# Park Hill School District

## **ADDENDUM No. 1** **Park Hill School District 2024 Asphalt Projects** **January 30, 2024**

#### **English Landing Elementary**

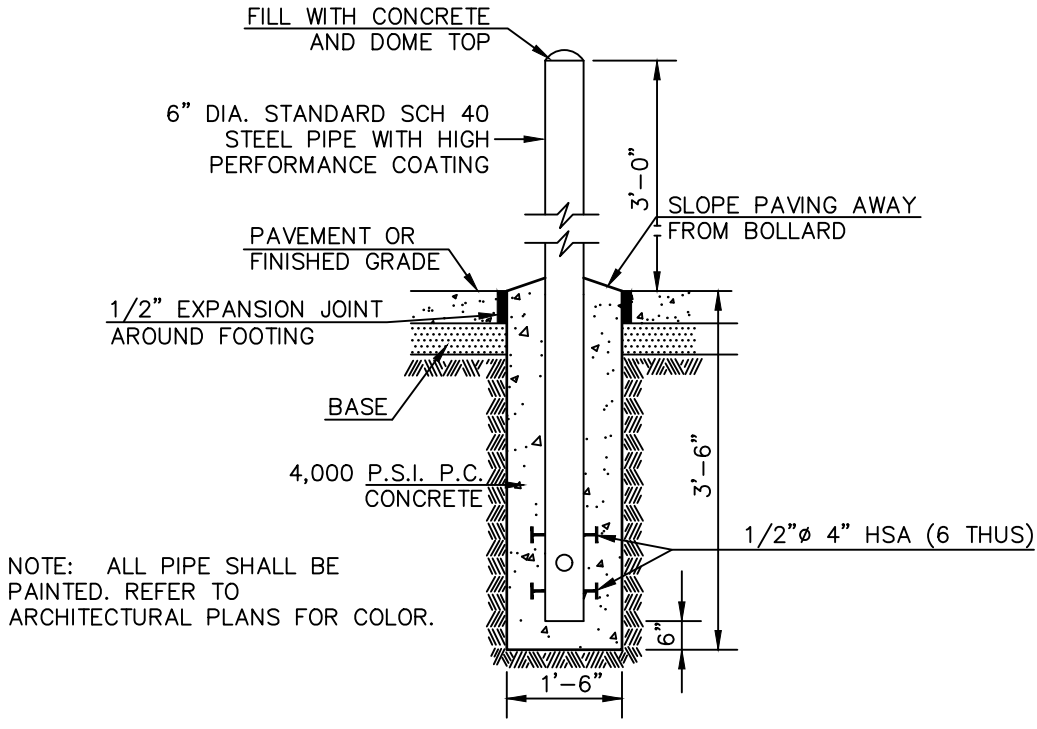
- In the Yellow outlined area **full depth mill with 6" HMA base replacement**  
- **Approximately 1,789 SY**
- Area A in red outline  
- **Approximately 7.5 Linear Ft** of curb and gutter replacement
- Area B in red outline area  
- **Approximately 10 linear ft** of curb and **approximately 5' linear ft** of spillway
- Replace asphalt curb along the north side with a concrete curb and gutter **approximately 100' LF**
- Install 4 bollards around fire hydrant approximately 4' O.C. not blocking fire nozzle per detail sheet.
